Interactive comment on “Prevailing climatic trends and runoff response from Hindukush–Karakoram–Himalaya, upper Indus basin” by S. Hasson et al.

Anonymous Referee #2

Submitted to: Earth System Dynamics Discussion Manuscript No. ESD-2015-12

Fig. 1. Delineation errors. Figure A is manuscript's Figure 2 at Page 648, while B is zoomed part of Figure A.

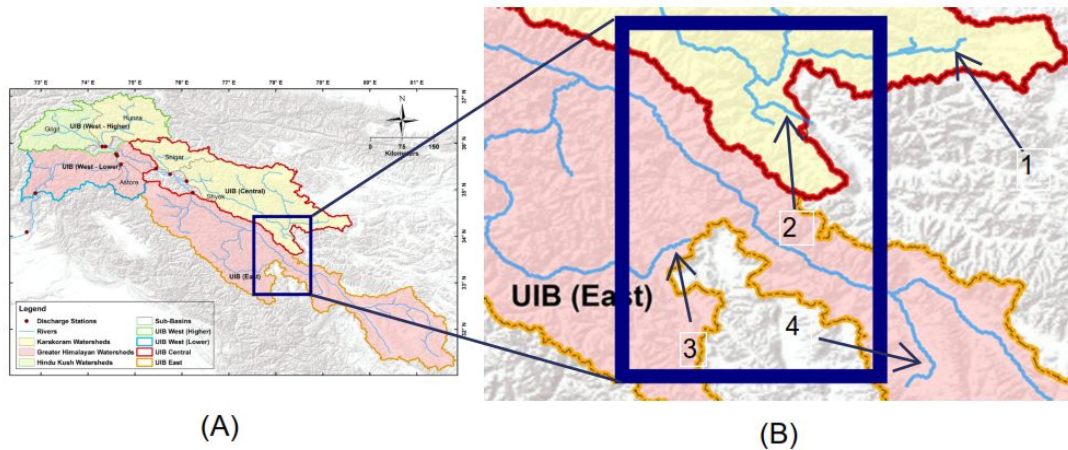
3. During delineation of a watershed boundary the stream network (particularly the start point of a stream) is generated based on either flow area (or number of cells draining to a downstream cell). This provides a stream network, well within the basin's boundaries. This provides nearly a uniform distance of stream network from the basin's

boundary. However, the stream network provided in Figure-2, page 648 does not provide nearly uniform distance from the exterior basin's boundary. In no case a stream should cross the basin's boundary (except at the basin's outlet), whereas near to the eastern part of the Shyok basin the stream 2 in following Figure B (zoomed part of Figure 2, page 648) crosses the outer basin's boundary. Similarly, stream 3 also nearly touches the boundary. The distance between boundary and streams is significantly variable (see streams 1-4, following Figure B). All this makes the delineation of the UIB doubtful. The authors need to address this issue, and have to carry out a re-delineation, together with a revision of the Figure.
